Noise Assessment

MANUKAU HARBOUR CROSSING – RESPONSE TO REQUEST FOR FURTHER INFORMATION FROM MANUKAU CITY COUNCIL

Marshall Day Acoustics (MDA) has received, from Resource and Environmental Management Ltd on behalf of Manukau City Council, a Request for further Information (dated 21 June 2006) in accordance with Section 92 of the RMA, in relation to the Manukau Harbour Crossing project. The request is in response to a review of Appendix 6 of the Assessment of Environmental Effects (AEE) accompanying the application.

Figure D Manukau Harbour Crossing

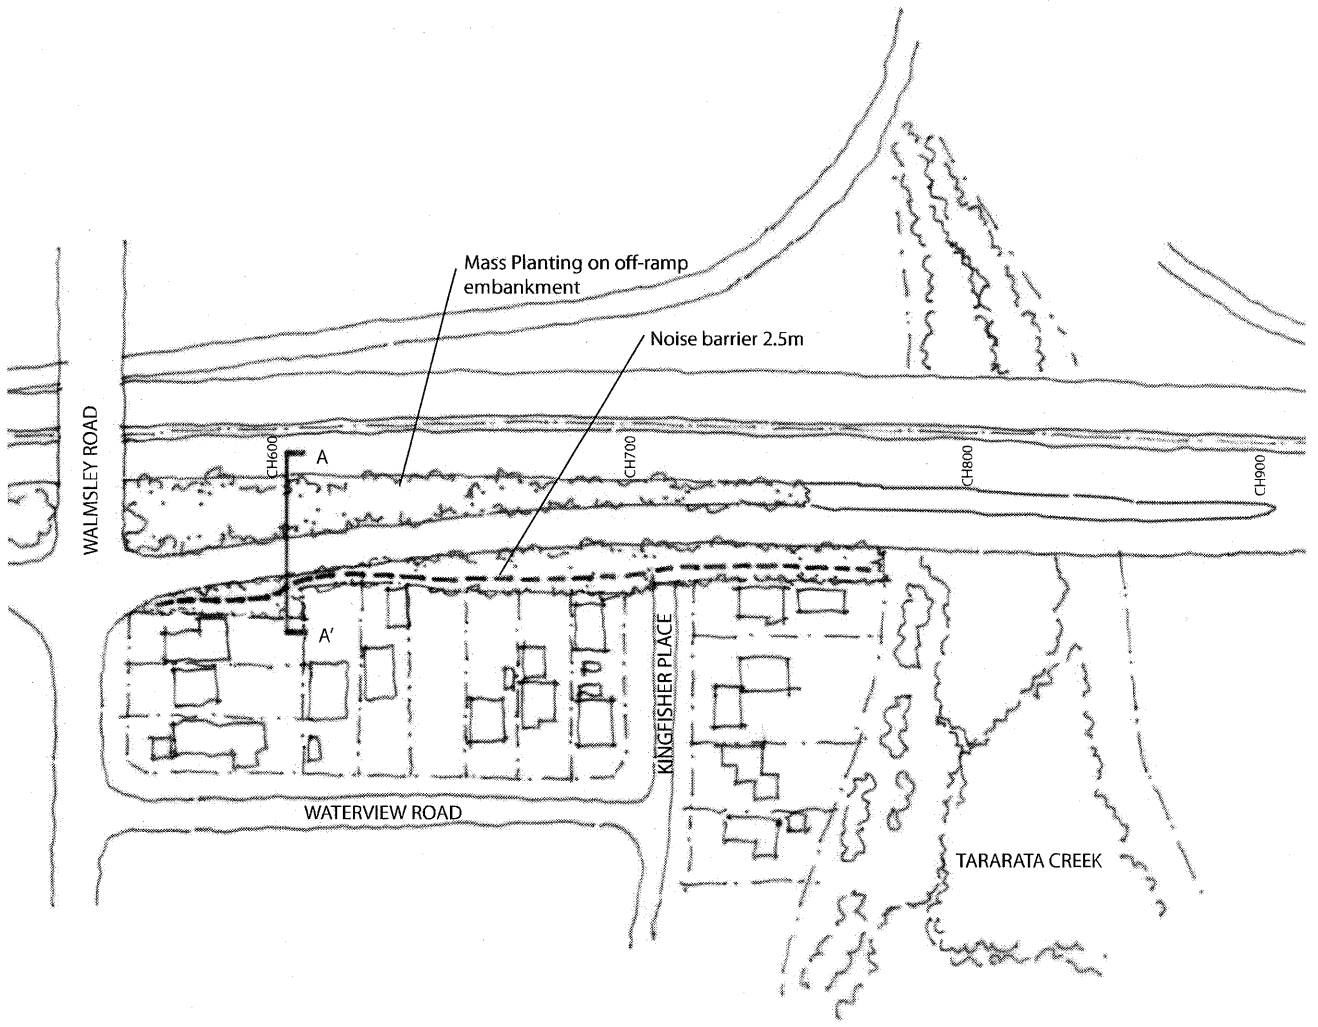
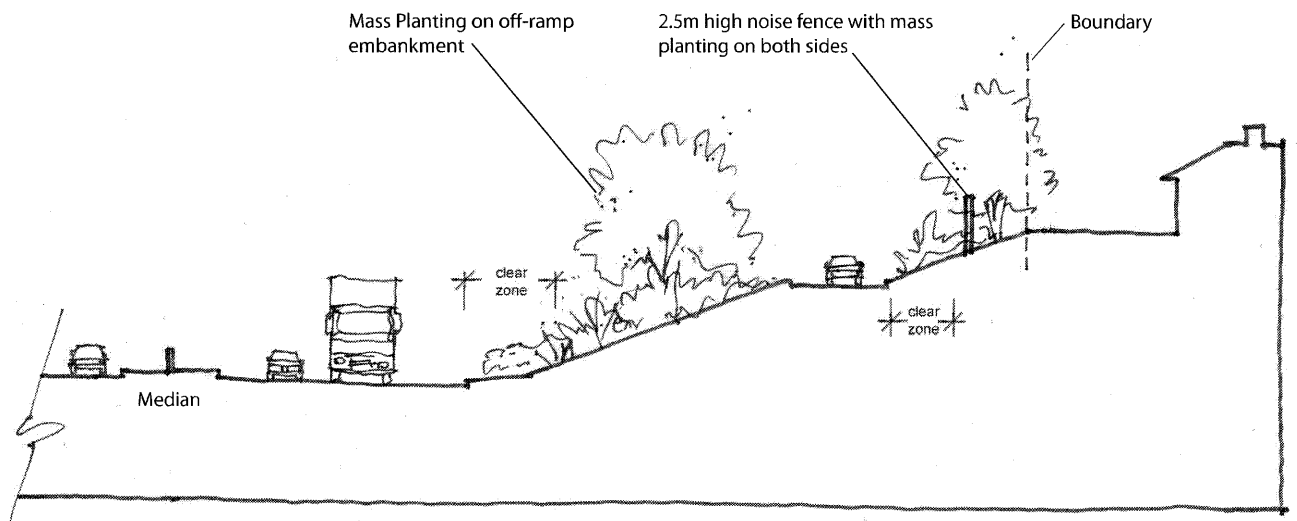
Further information is sought relating to an evaluation of alternative mitigation measures for the stretch of SH20 where the 2.5 metre high barrier has been proposed (just north of the Coronation Road on-ramp).

A further iteration of the noise model has been undertaken, whereby the noise barrier is moved closer to the carriageway and reduced in height to 2m. The barrier has also been reduced in length. The results of the revised modelling show that it would not be possible to screen this area and comply with the Transit Criteria with a lower barrier.

However, it should be noted from Figure G2 of Appendix 6 of the AEE, that the need for a barrier is mainly as a result of the exceedance of the Transit design levels at the MCC subdivision 1 and MCC subdivision 2 receivers (refer Figure G2 and the table appended to this letter). These are located on ground higher than the carriageway and therefore the barrier is in the most effective location for acoustical purposes.

It is accepted that the barrier does not have to extend as far south as originally shown, rather only to the point shown on revised Figure D appended to this letter.

Case No. 1: Walmsley Road Off-Ramp (CH600)

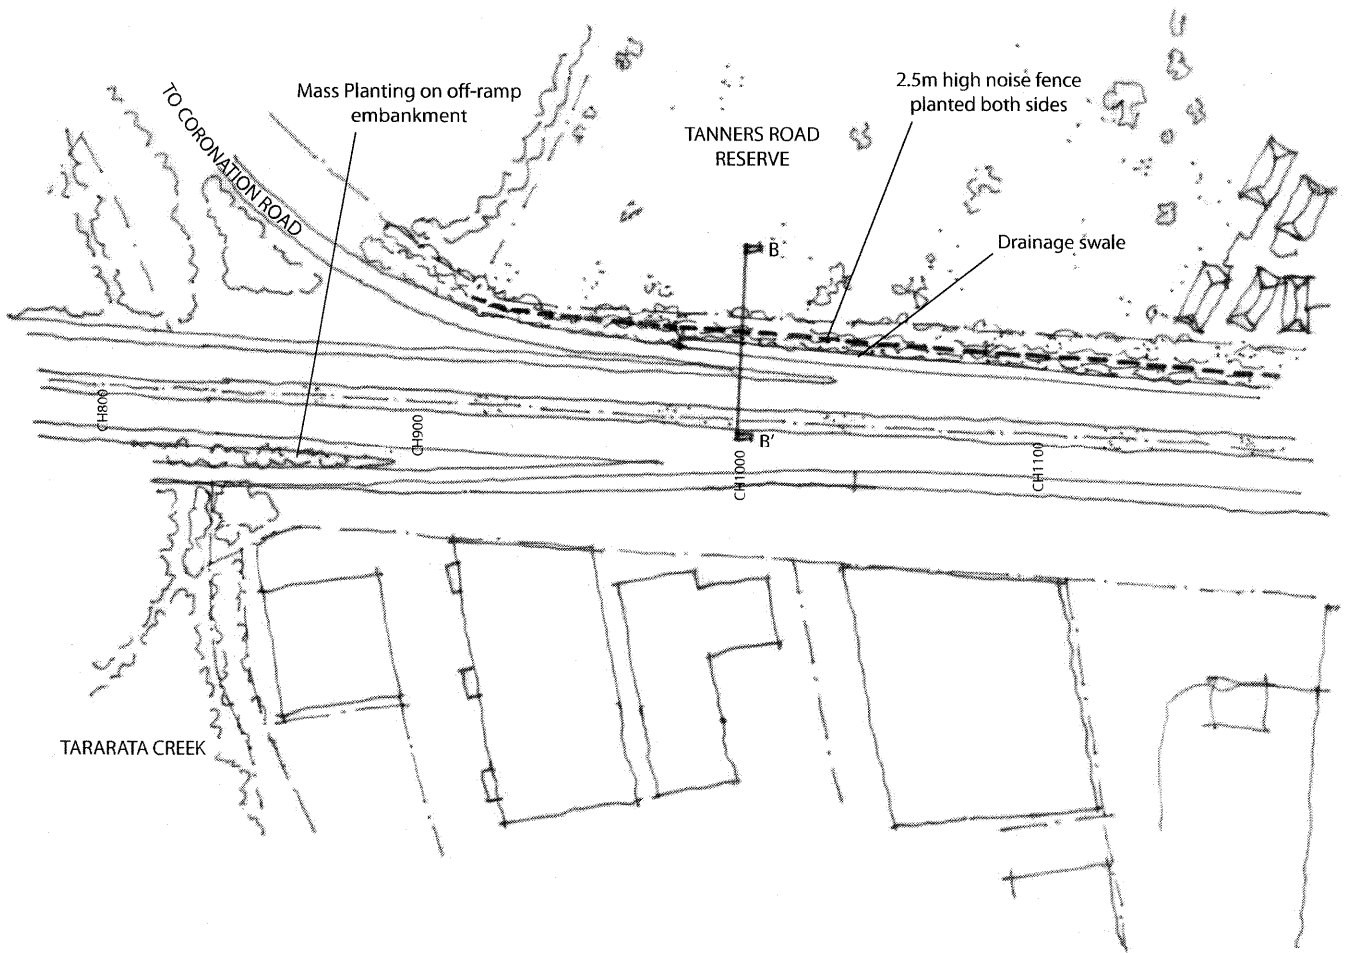
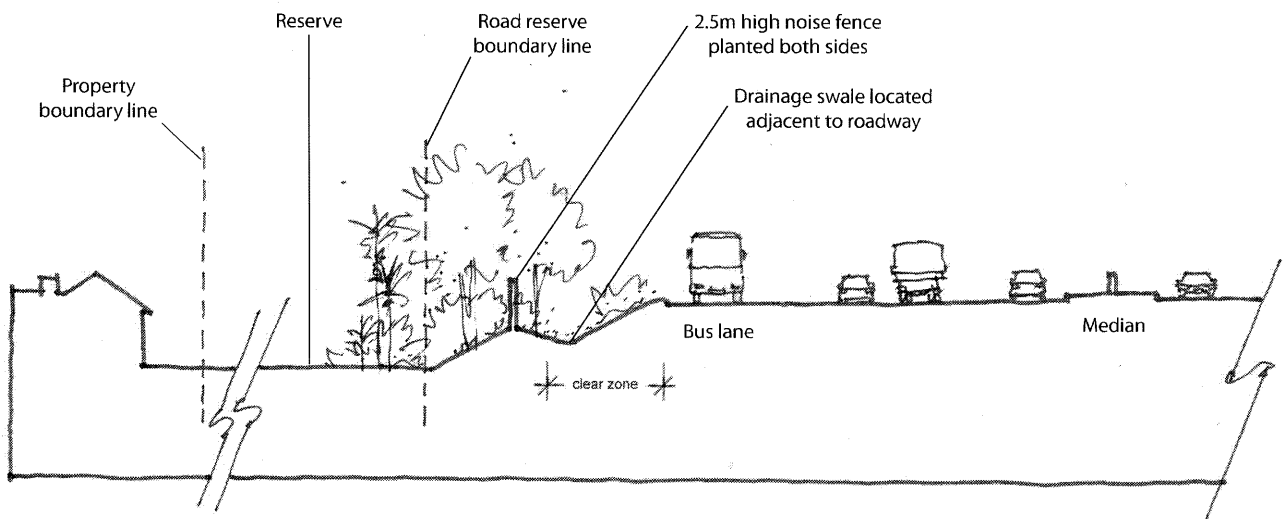
Further information is sought relating to an assessment of noise effects resulting from moving the barrier currently proposed at the top of the cutting adjacent to the southbound Walmsley Road off-ramp, to a position lower "down the bank".

Predictions at alternative locations (lower down) and with alternative heights were undertaken but the design levels could not be met.

The barrier provides enough screening to ensure the Transit design level is just met at the worst case receiver location. If the barrier were moved (ie on a lower elevation) then the barrier height would have to increase to provide the same amount of screening. This height increase was predicted to be significant and hence was discarded in the modelling process.

Case No. 2: Tanners Road (CH1000)

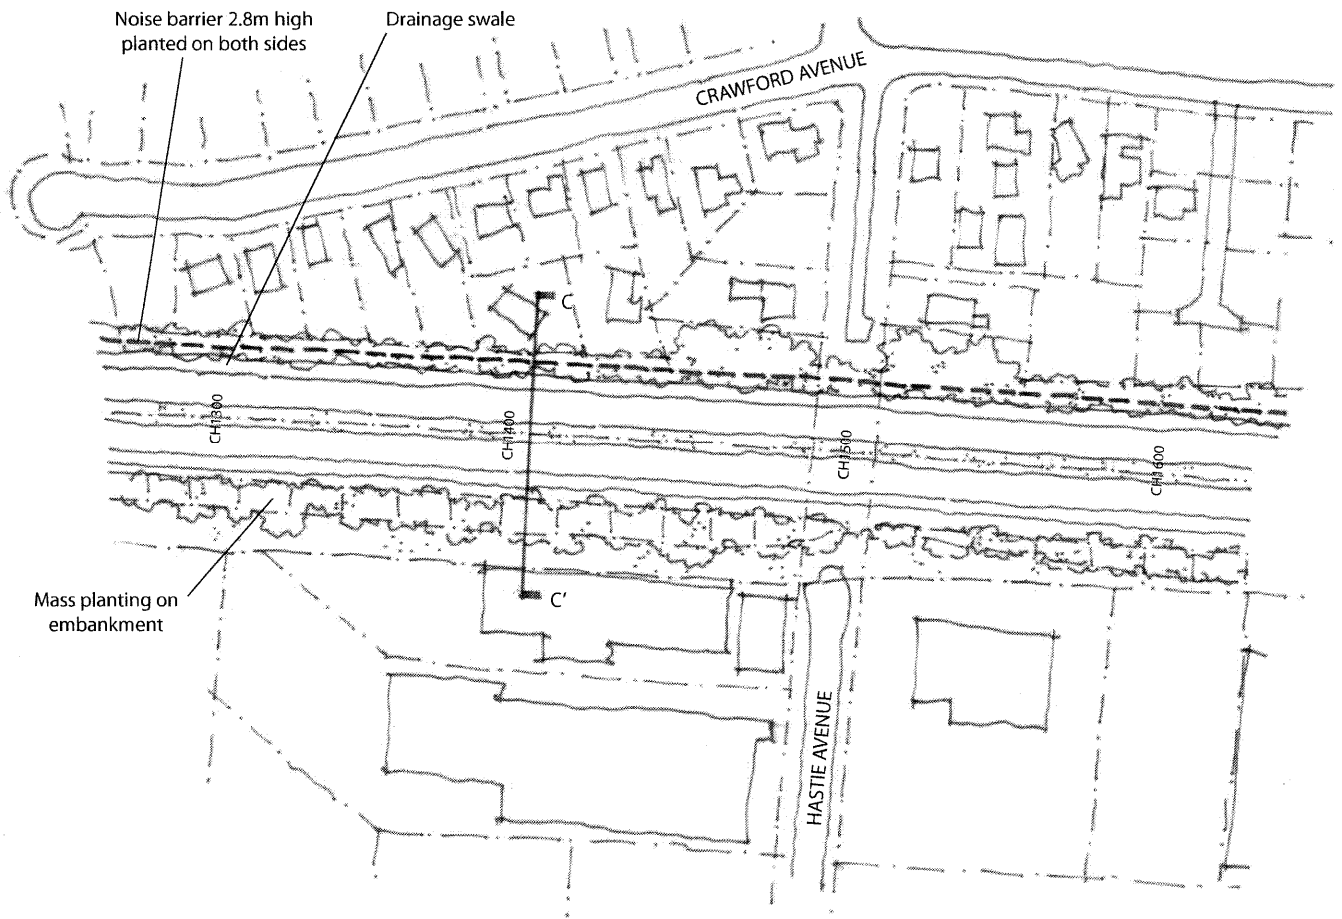
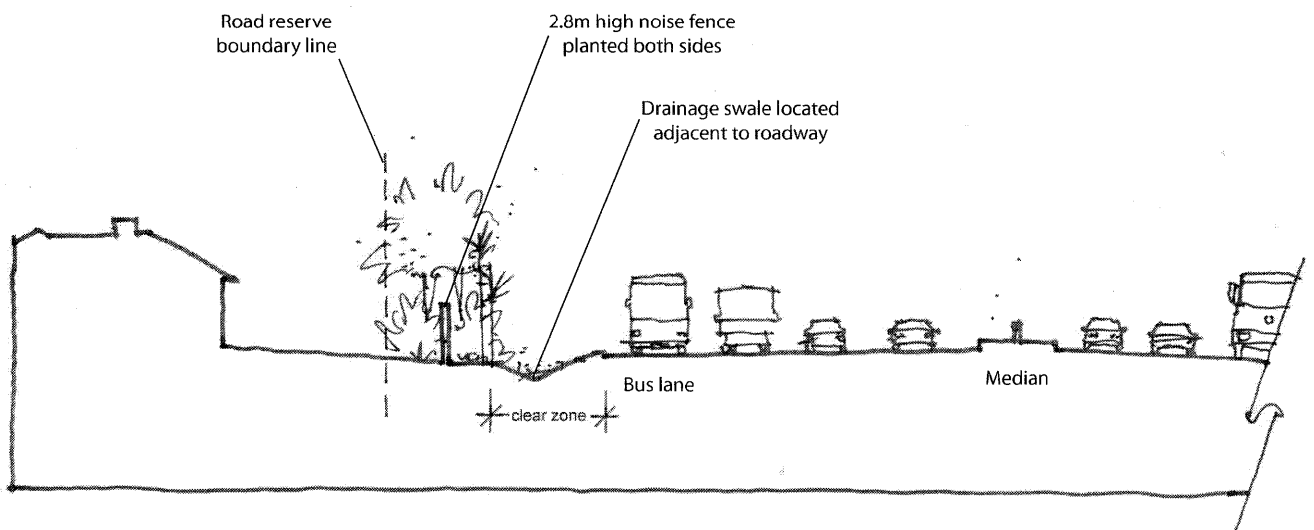
- 1. Cross-sections – on each of the cross-sections provided, a graphical representation of the edge of the designation and the location and height of noise mitigation barriers. It is considered that this may reveal that in some cases, the noise mitigation measures may not be particularly effective.*
- 2. For the noise mitigation barriers, a more explicit consideration of the height, location and visual impact of the structures, and the factors that have gone into locating the barriers where they are. In this regard, it is noted that any motorway reserve space between the noise barrier and the designation boundary will be land with an ambiguous status and not good crime-reducing design.”*

The detailed design for the project will include consideration of how to manage the motorway reserve between the noise barriers and the designation boundary. Crime prevention through environmental design principles will form an essential part of the process. The results of consultation with property owners immediately adjoining the designation boundary and the requirements for the noise barriers will also influence the process.

Each block likely will be considered on a case by case basis. In any event the CPTED principles most applicable to the scenario will be applied. Natural access controls in the form of fencing could be erected along all public boundaries to limit access, territorial controls through the erection of “no access” signage and target hardening by securing access gates used by Transit’s maintenance staff / contractors. Low level natural surveillance may also be provided from properties immediately adjoining the designation.

Case No. 3: Hastie Avenue (CH1400)

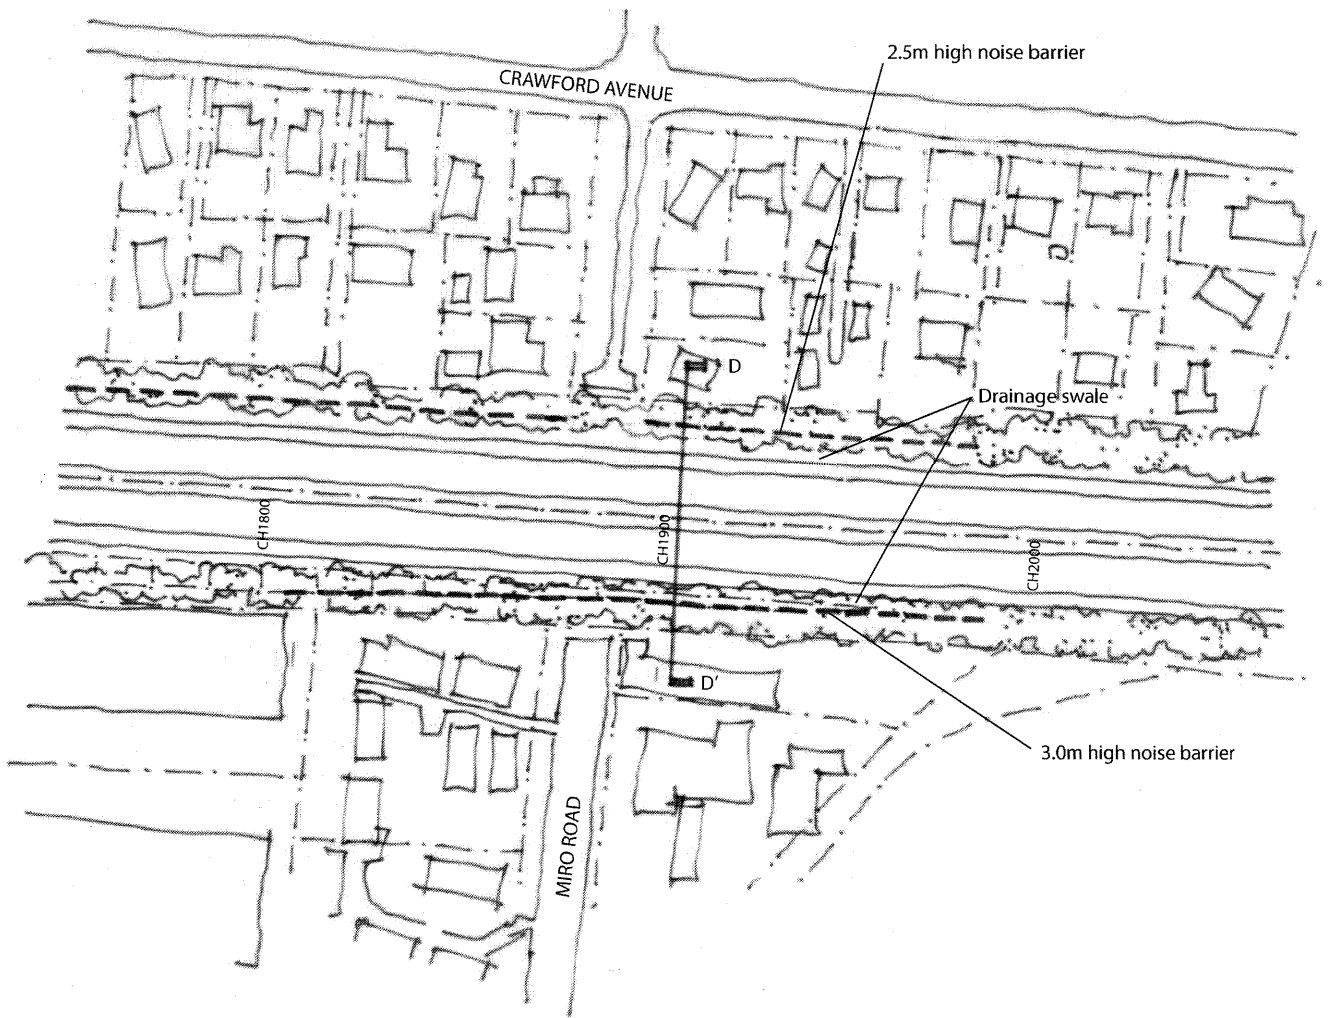
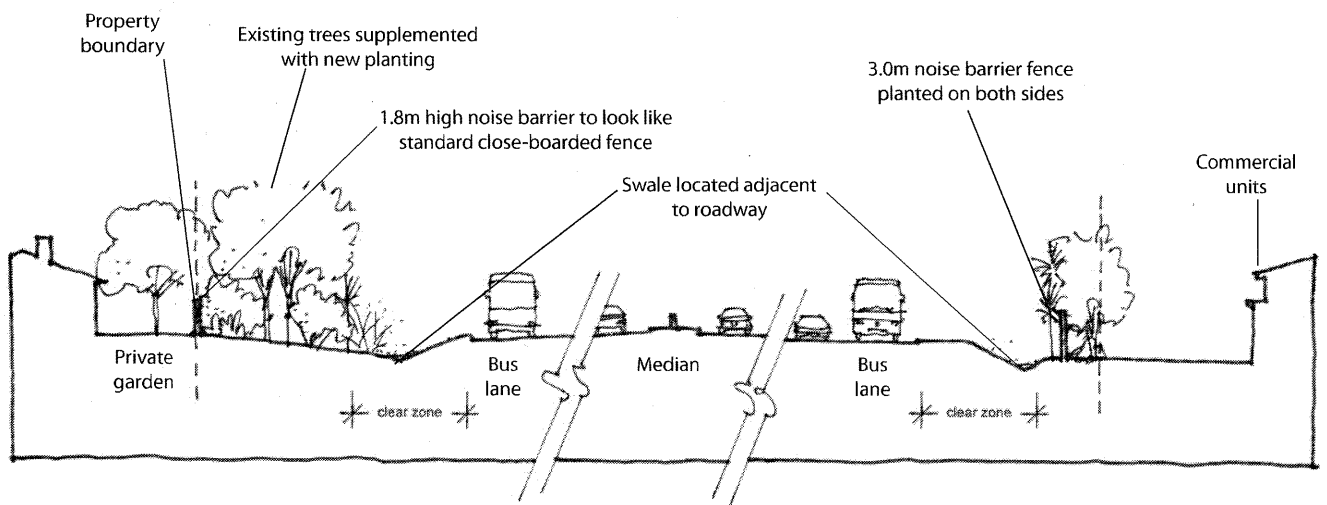
Further information is sought in relation to an evaluation of alternative mitigation measures for the stretch of SH20 where the 2.5 metre high barrier has been proposed (running adjacent to SH20 from the boundary of Hasties Place in the south to Miro Road in to the north).

Again, a revised barrier design that splits the barrier into two discrete parts has been modelled. The discontinuation of the barrier at the end of Miro Road has also been addressed and modified. The original barrier is continuous at this location.

The barrier has been modelled at 1.8m high adjacent to the bus lane for the section of barrier north of 50C Crawford Avenue

The section between Hasties Place and 50C Crawford Avenue has been retained at the current height (2.5m) and location (adjacent to the bus lane). This is because the original modelling shows this is the area where compliance with the design levels was the most
